CHANGE ORDER

CHANGE ORDER NUMBER
3
4/18/2022
Page 1 of 10

<input checked="" type="checkbox"/> ORDERED BY ENGINEER UNDER SECTION 1-04.4 OF THE STANDARD SPECIFICATIONS. <input type="checkbox"/> CHANGE PROPOSED BY CONTRACTOR.	PROJECT IDENTIFICATION PROJECT NAME: North Creek Trail Phase 1 – SR524 to Sprague Drive PROJECT NUMBER: RC1776, RR6318, RR6323, RR6319, RC1798
CONTRACTOR ENDORSEMENT: <div style="display: flex; justify-content: space-between;"> SIGNATURE DATE </div> <hr/> <div style="display: flex; justify-content: space-between;"> PRINT NAME TITLE </div>	CONTRACTOR: Rodarte Construction, Inc. ADDRESS: 17 East Valley Hwy E Auburn, WA. 98092

This Change Order compensates the Contractor for added work required to grind and pave a full-width HMA overlay on Filbert Drive and Winesap Road adjacent to the North Creek Trail Phase 1 Project.

REFERENCE SHEET NO. CH03
SHEET 126 OF 171 SHEETS

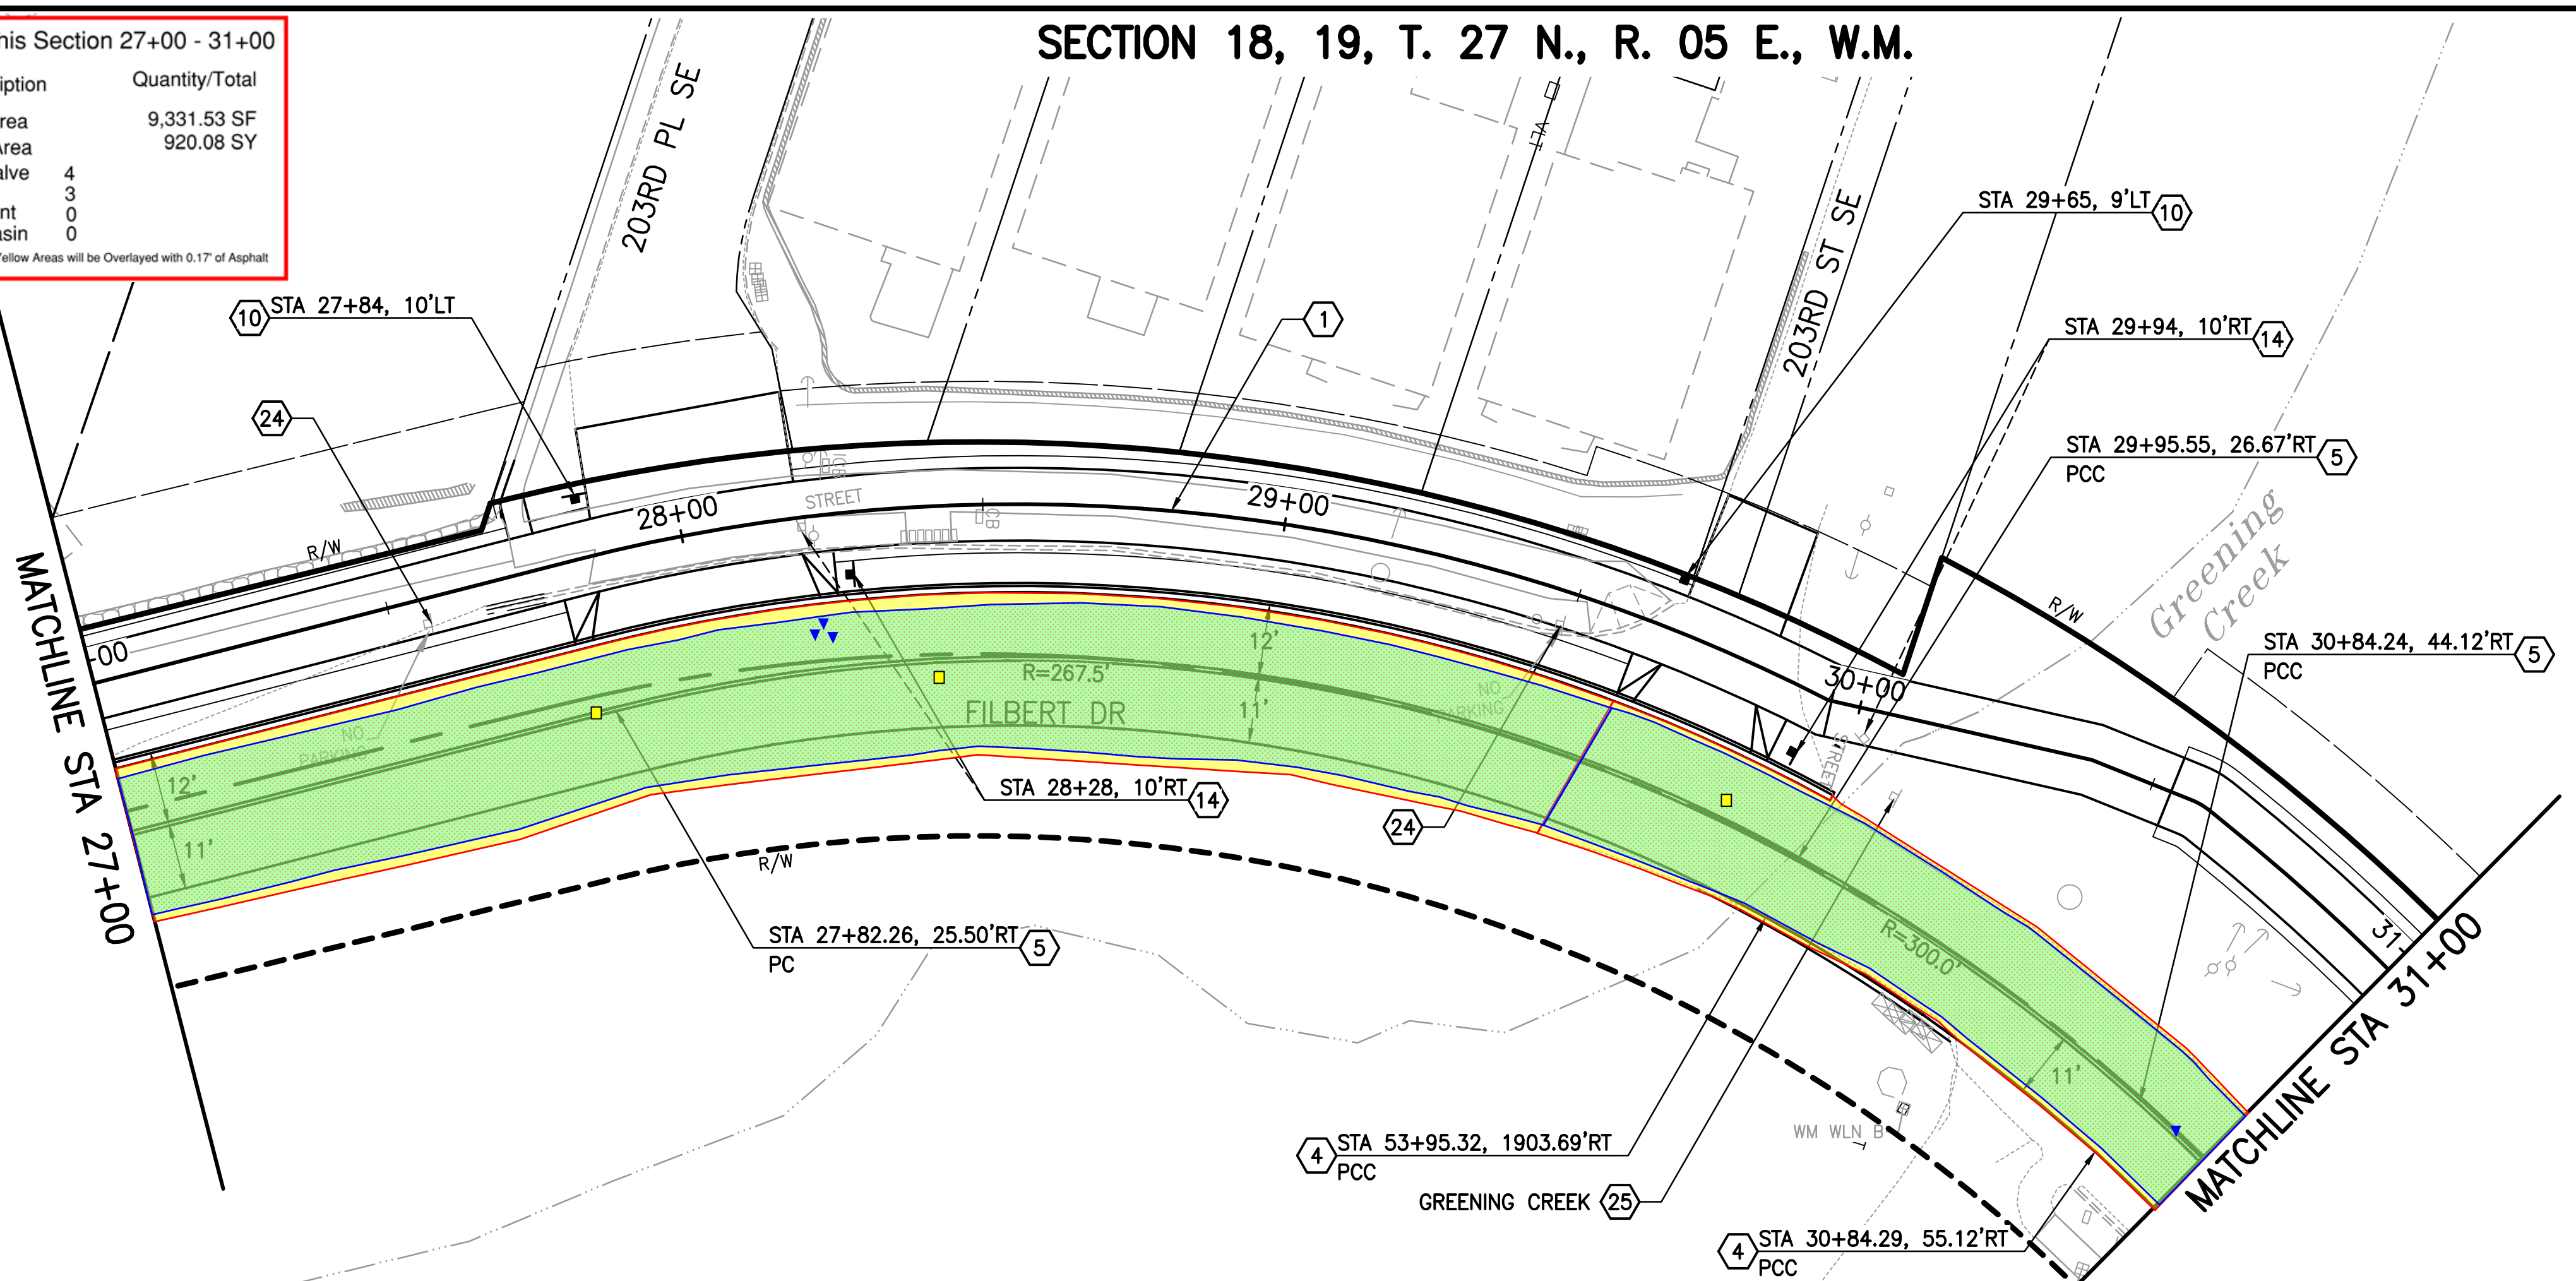
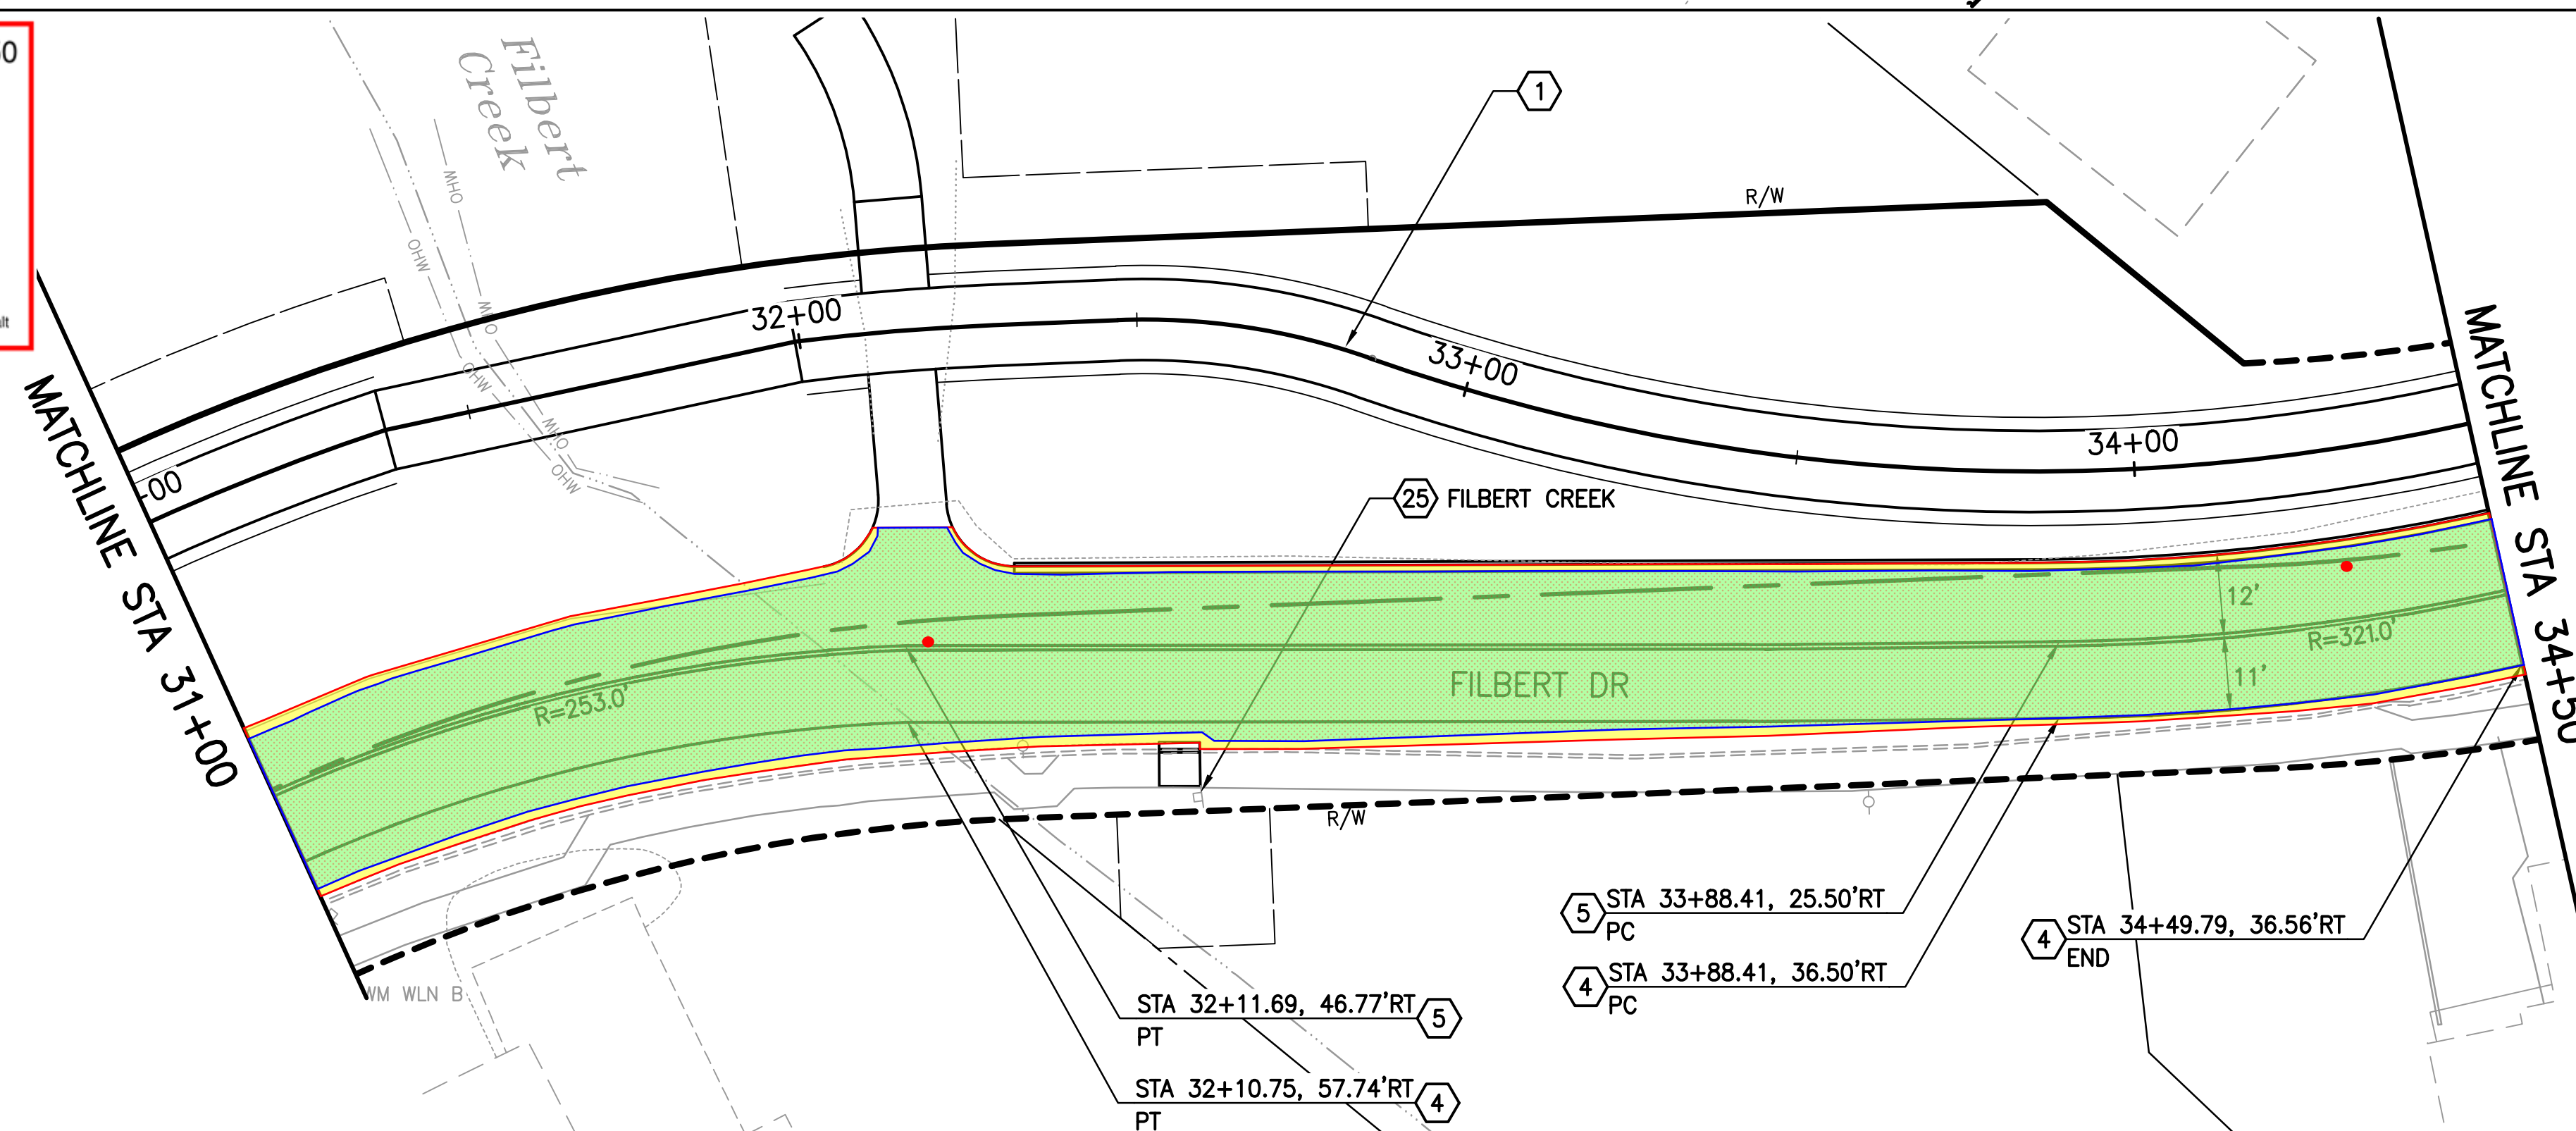
Legend This Section 27+00 - 31+00

Description	Quantity/Total
Paving Area	9,331.53 SF
Planing Area	920.08 SY
Water Valve	4
Sewer	3
Monument	0
Catch Basin	0

* Both Green and Yellow Areas will be Overlaid with 0.17" of Asphalt

Legend This Section 31+00 - 34+50

Description	Quantity/Total
Paving Area	8,786.28 SF
Planing Area	889.41 SY
Water Valve	0
Sewer	0
Monument	0
Catch Basin	0

* Both Green and Yellow Areas will be Overlaid with 0.17" of Asphalt
